Access Compliance Report

Public Rights-of-Way

(Curb Ramps)

Intersection ID: 10021845	Main Street: BRIXHAM_HILL_AV	Cross Street: N/A	Location: SW
ADA ID: 5A8661792231	Ramp Type: Perp	Initial Pass/Fail: Fail	Overall Compliance: No
		Severity Score: 22.5

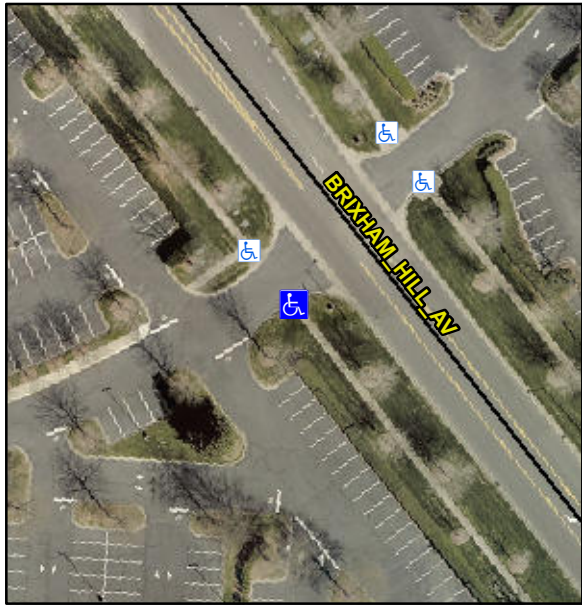
Codes/Mitigation Info/Possible Solution			Field Measurements/Component Compliance					
	Possible Solutions:		Compliance	Description	Data	Compliance	Description	Data
	Remove & Replace Entire Ramp.		N/A	Ramp Length (in)	94.0	No	Ramp Slope (%)	9.2
			No	Ramp Width (in)	46.5	No	Ramp XSlope (%)	3.4
			N/A	Flare Type LT	N/A	N/A	Flare Type RT	N/A
			N/A	Flare Slope LT (%)	N/A	N/A	Flare Slope RT (%)	N/A
			N/A	Flare Traversable LT?	N/A	N/A	Flare Traversable RT?	N/A
			N/A	Landing Length (in)	N/A	N/A	DWS Provided?	N/A
			N/A	Landing Width (in)	N/A	N/A	DWS Contrast?	N/A
			N/A	Landing Slope (%)	N/A	N/A	DWS Length (in)	N/A
			N/A	Landing X Slope (%)	N/A	N/A	DWS Full Width?	N/A
Surveyor Notes:	N/A		N/A	Landing Curb? (Y/N)	N/A	N/A	DWS Offset (in)	N/A
			N/A	Shared Landing?	N/A			
	PROW/ADA:		N/A	Gutter Ponding?	N/A	N/A	Gutter Slope (%)	N/A
	R304.5.1, R304.2.2, R304.5.3		N/A	Gutter Lip Ht (in)	N/A	N/A	Gutter X Slope (%)	N/A

N/A	Painted X Walk1?	No	N/A	Painted X Walk2?	N/A
				X Walk 1 Direction	To NW		X Walk 2 Direction	N/A
			N/A	X Walk 1 Width (in)	N/A	N/A	X Walk 2 Width (in)	N/A
				X Walk 1 Slope (%)	2.2		X Walk 2 Slope (%)	N/A
				X Walk 1 X Slope (%)	2.7		X Walk 2 X Slope (%)	N/A
			N/A	Ramp inside XWalk1?	N/A	N/A	Ramp inside XWalk2?	N/A
			Road Slope (%)	N/A	N/A	Clear Space?	N/A	
			Road X Slope (%)	N/A	N/A	Clear Space to XWalk (in)	N/A	
		N/A	Any Obstructions?	N/A	N/A	Storm Grate/Utility Hazard?	N/A	
			Obstruction Type			Storm Grate/Utility Type		
					N/A		N/A	
						Yes	Surface Condition? (G/P)	Good
Total Cost:		\$ 1850.00
